Planning & Development Division
Planning & Economic Development Department

File Number	PL 23-186	Contact	Jenn Moses	
Type	MU-I Planning Review	Planning Commission Date	November 14, 2023	
Deadline for Action	Application Date	October 19, 2023	60 Days	December 18, 2023
	Date Extension Letter Mailed	N/A	120 Days	February 16, 2024
Location of Subject	1012 E 2 nd St			
Applicant	St. Luke's Hospital	Contact	Michael Boeselager	
Agent	Erdman Company	Contact	Neil Bright	
Legal Description	See attached	Sign Notice Date	October 31, 2023	
Site Visit Date	October 31, 2023	Number of Letters Sent	4

Applicant is proposing a new skywalk directly above an existing skywalk over 10th Avenue E, connecting St. Luke's Hospital to Building A.

**ELEVATIONS AND
3D RENDERING**

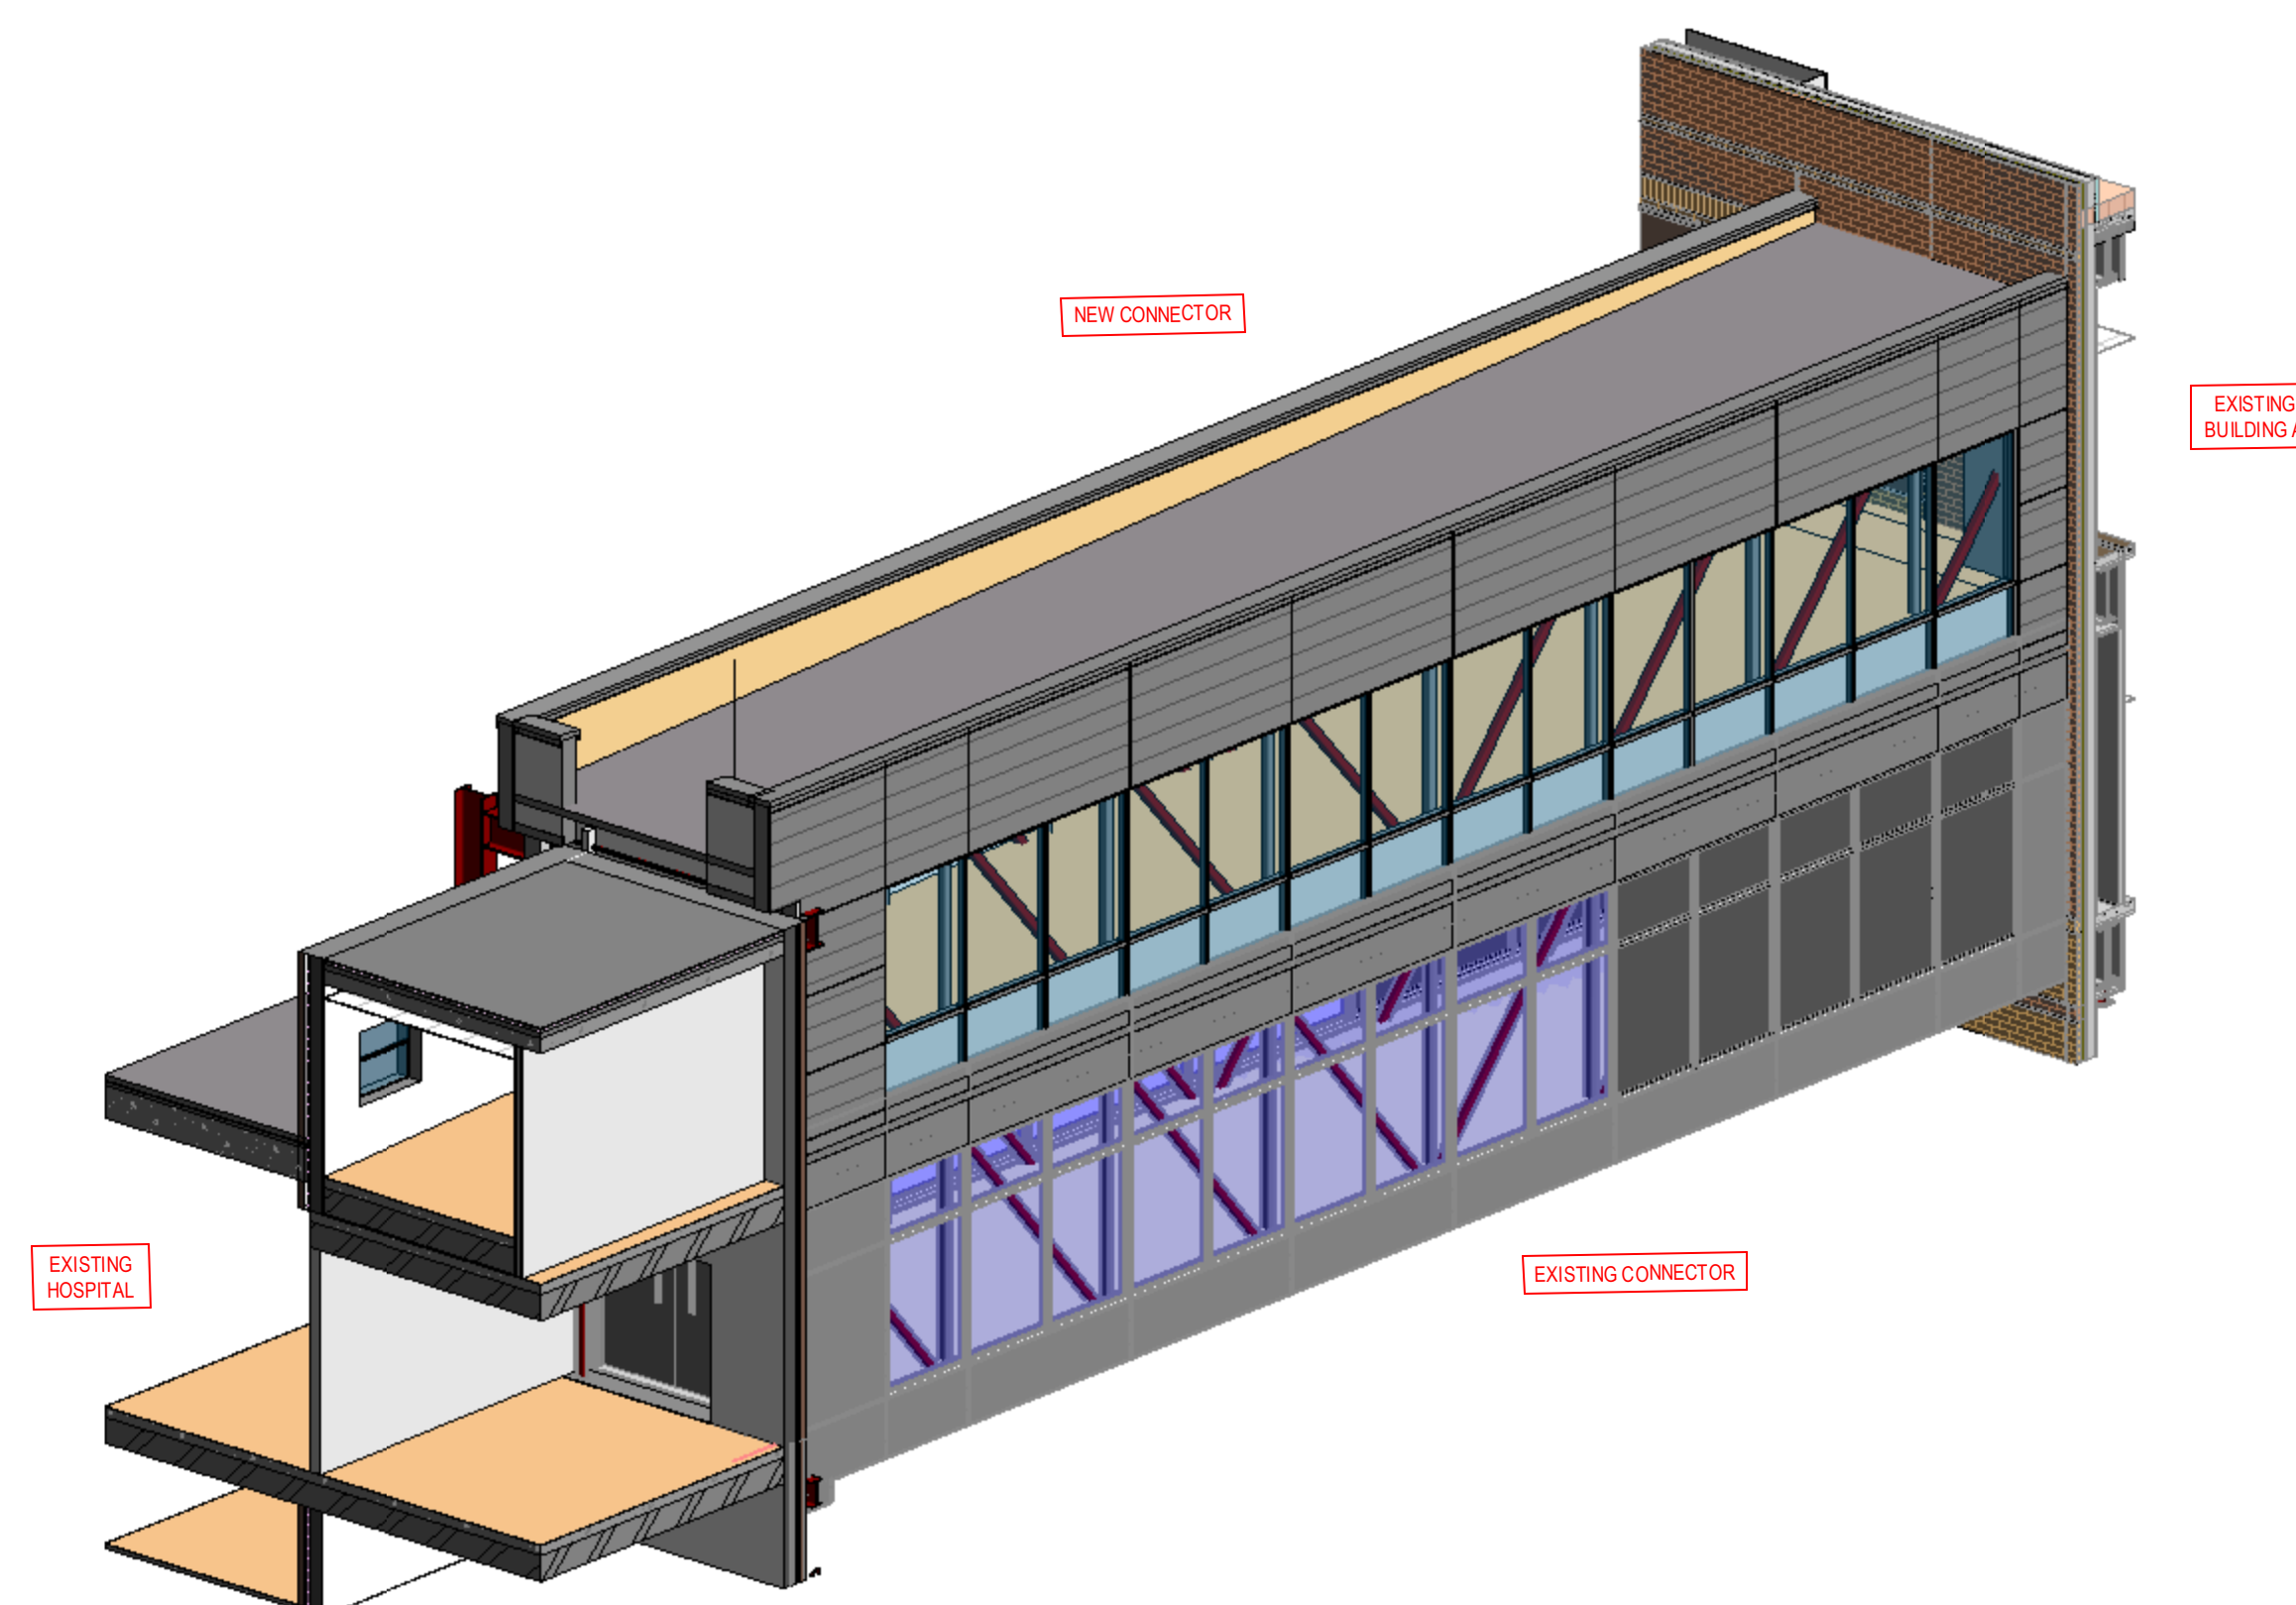
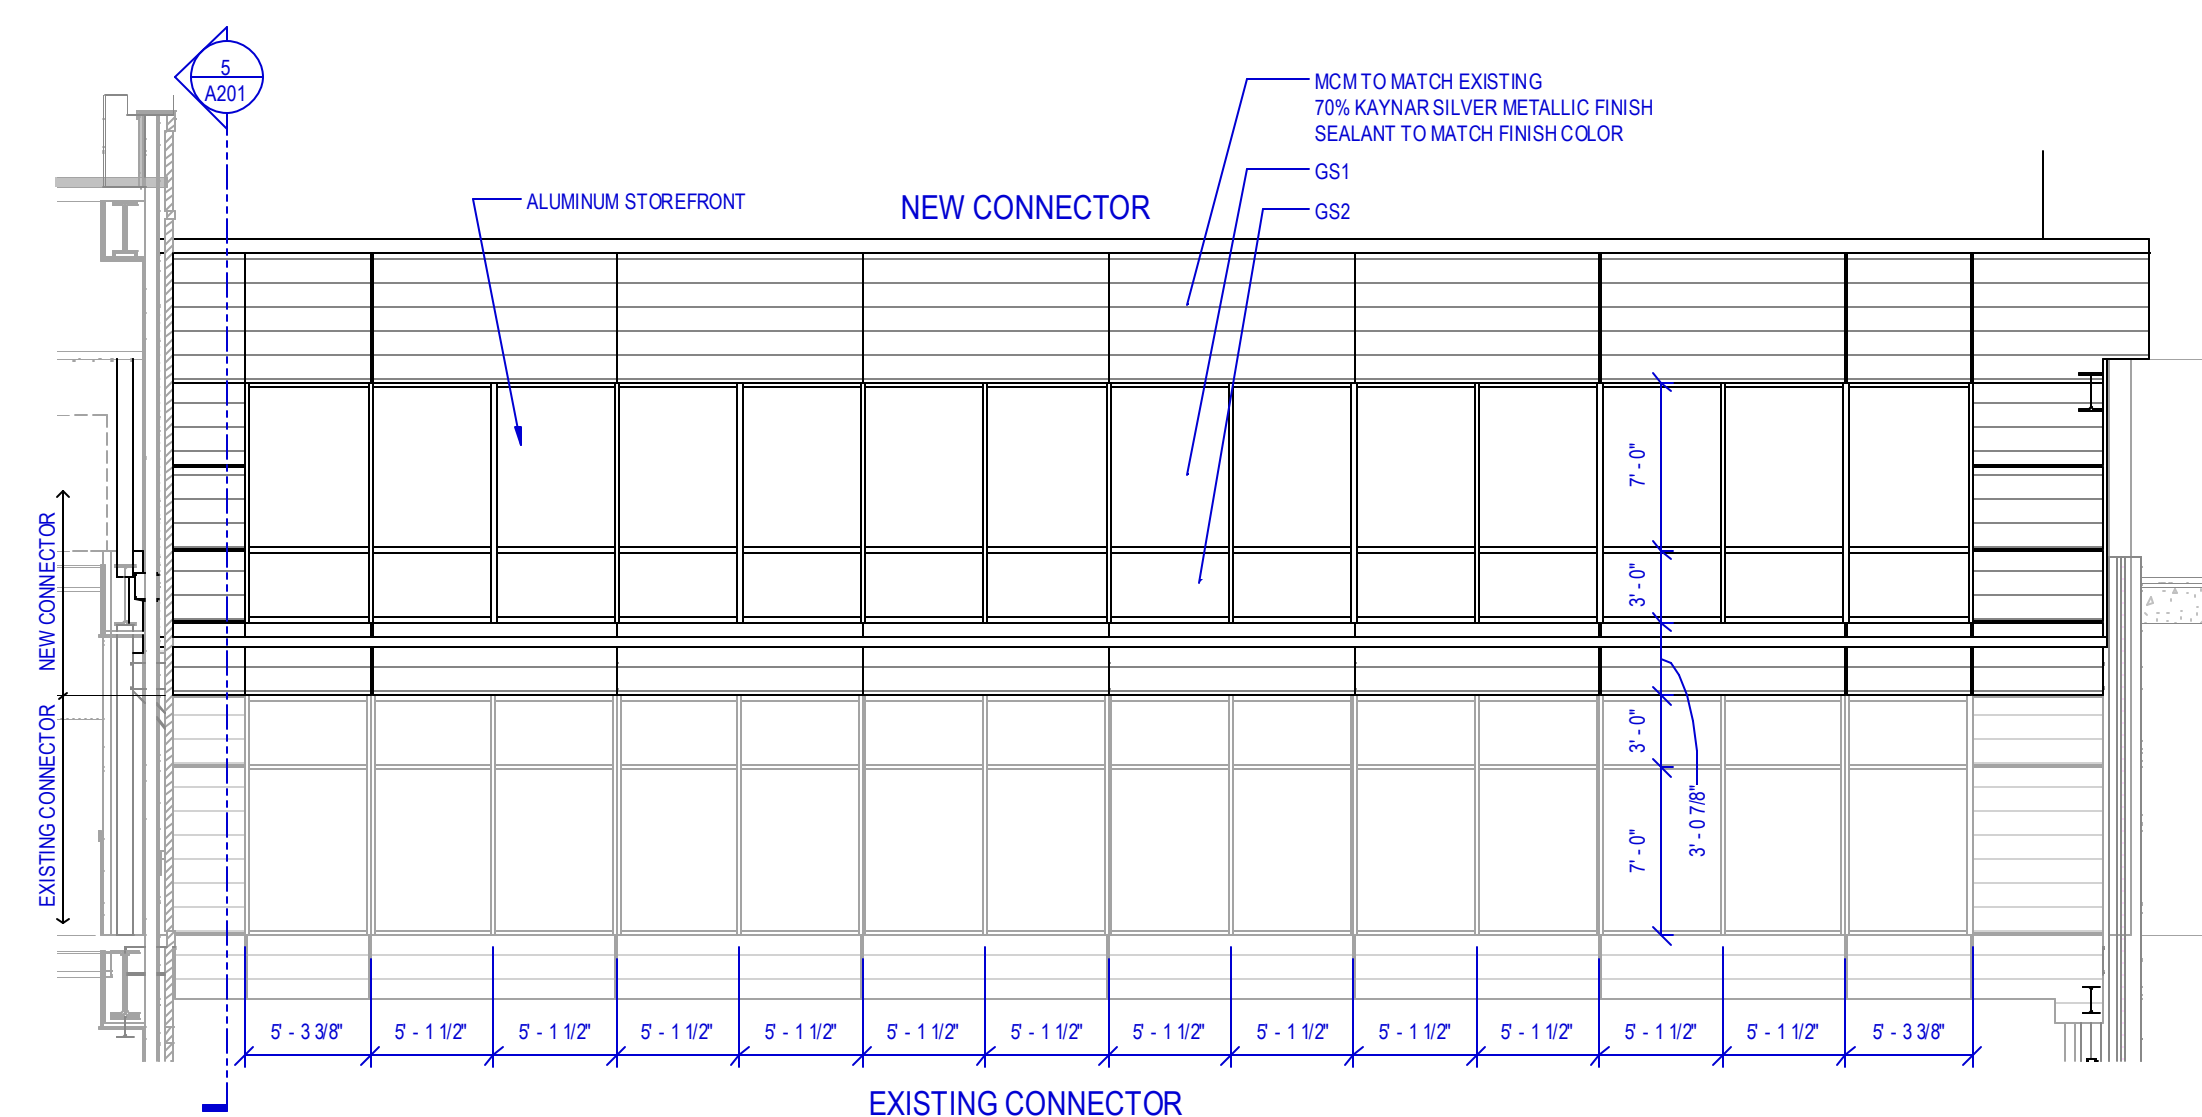
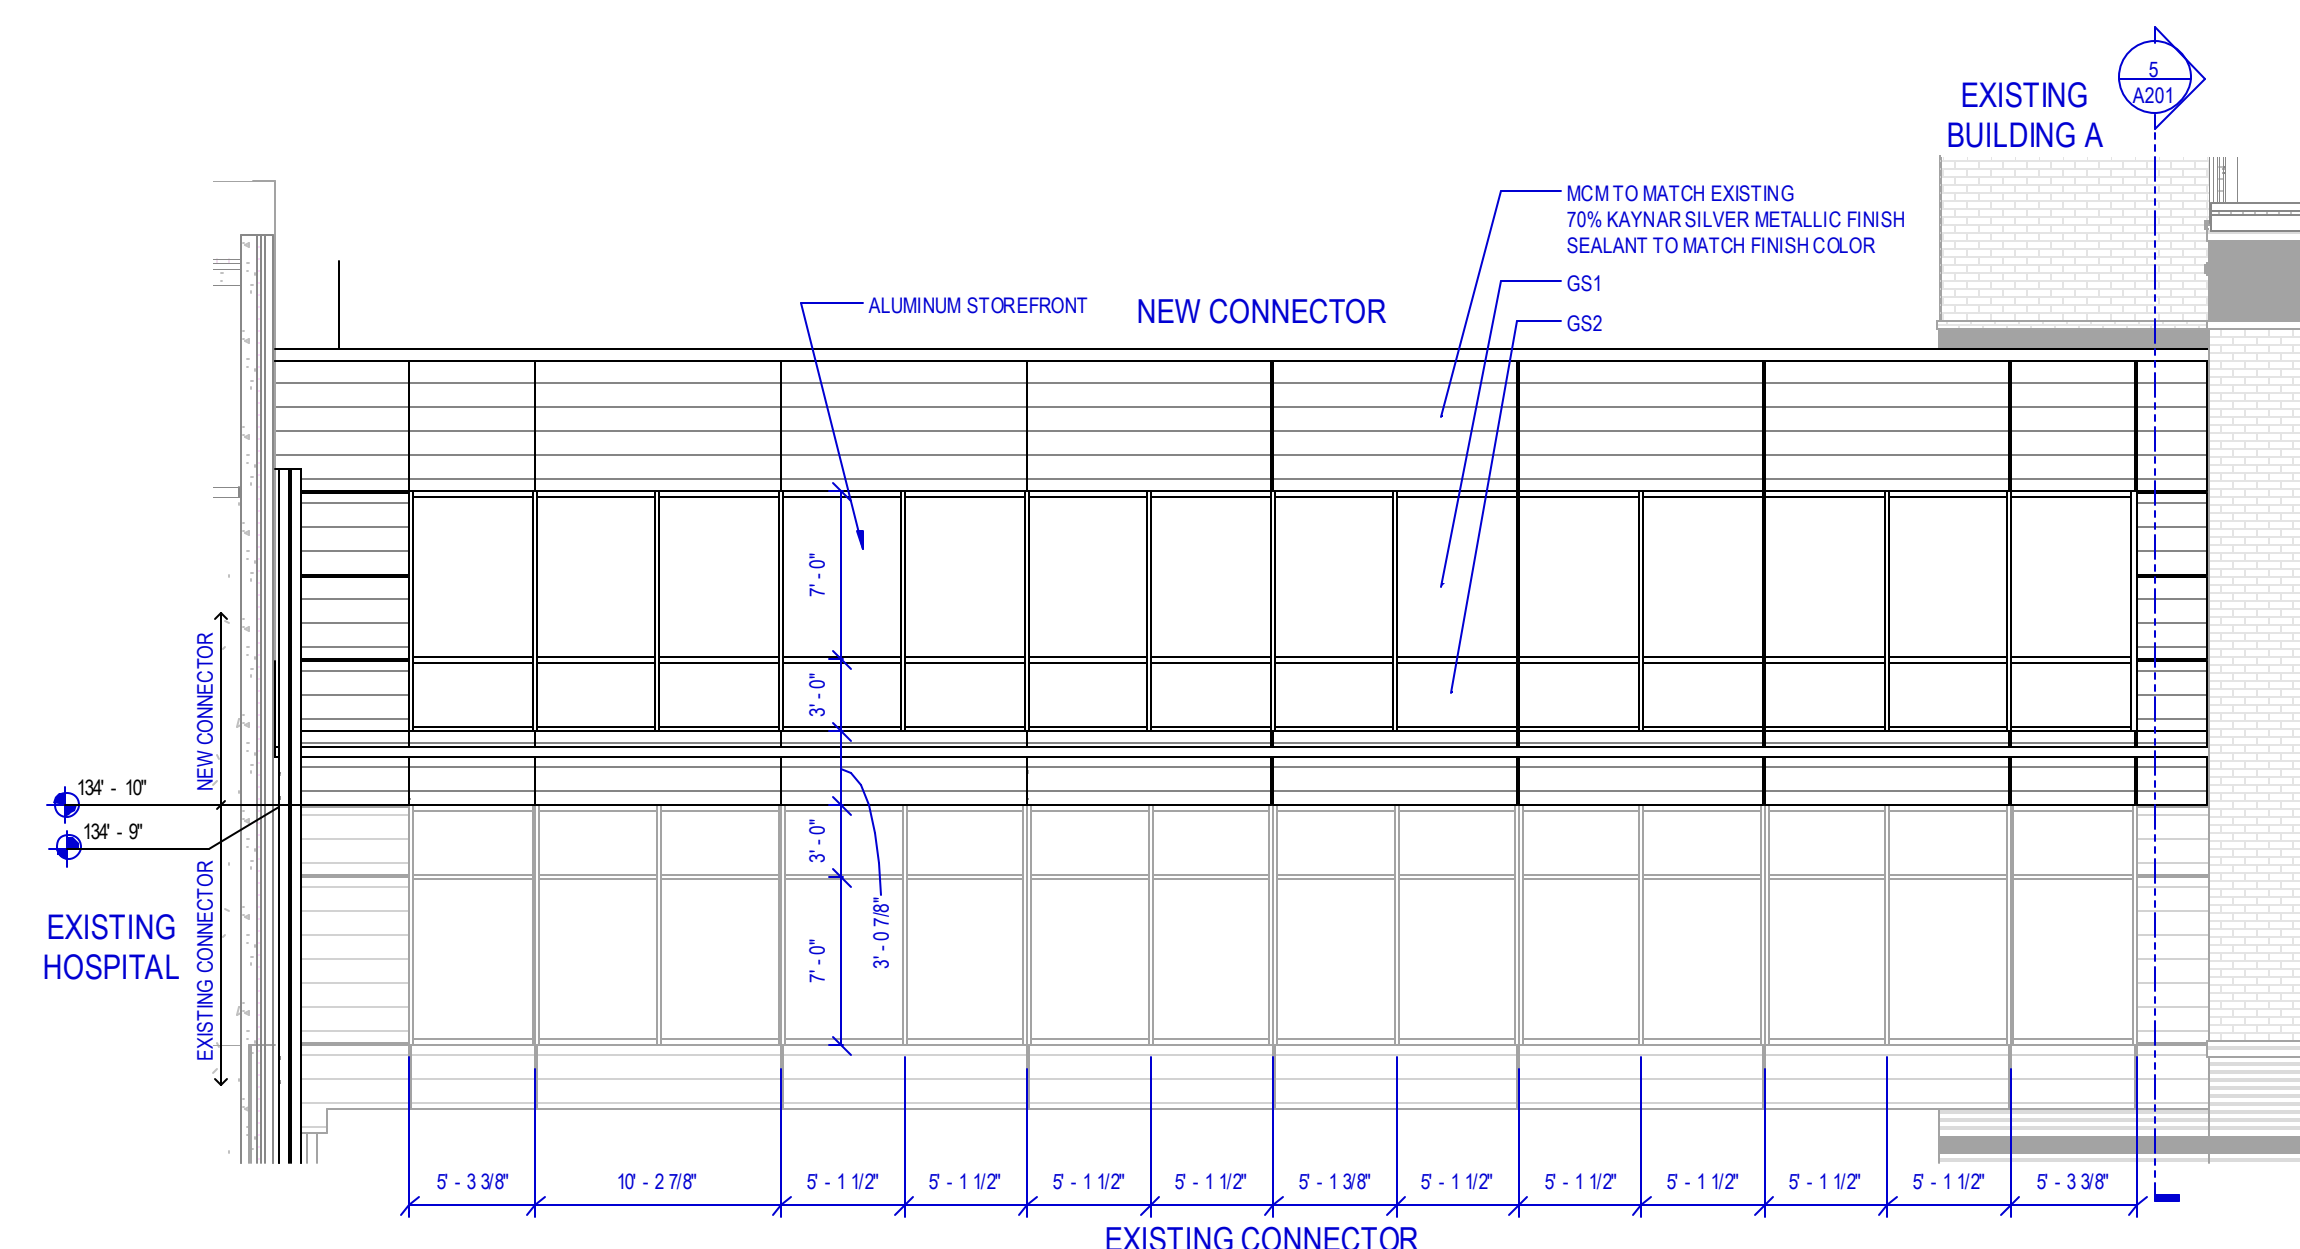
- 2) UDC Section 50-23.6, Skywalks, states that skywalks should not compromise the historic or architectural integrity of existing buildings, shall be approved based on architectural sensitivity and cohesiveness, and that 66% of each vertical side elevation shall be made of glass or transparent materials. The building elevations and 3D rendering submitted with the application show that this skywalk is designed with window openings that vertically line up with the skywalk directly below. Structural elements and exterior materials will blend with the connector below, giving these skywalk connections a unified feel within the hospital campus. Each window opening is approximately 50 square feet, for a total of 700 square feet per side. With the addition of spandrel glass, the skywalk provides 54% transparency. According to the applicant, "We would consider 66% infeasible due to the fact this connector will help bridge 4' of vertical difference between the floors on the two buildings leading to a sloped floor and structure. We also are attempting to avoid roof penetrations in the form of roof drains which require maintenance and create leak points so the roof is sloped as well which also means the structure is sloped. With the sloped floor along with a sloped roof structure, we are limited in our ability to provide 66% transparency but will provide the minimum 50% or more as we continue to refine our design."

1. The project be constructed, limited to, and maintained according to the plans and building elevations submitted with this application.
2. The Planning Review shall only be effective upon approval and issuance of a Concurrent Use Permit for the placement of the structure in the right-of-way.
3. Any alterations to the approved plans that do not alter major elements of the plan may be approved by the Land Use Supervisor without further Planning Commission approval; however, no such administrative approval shall constitute a variance from the provisions of Chapter 50.
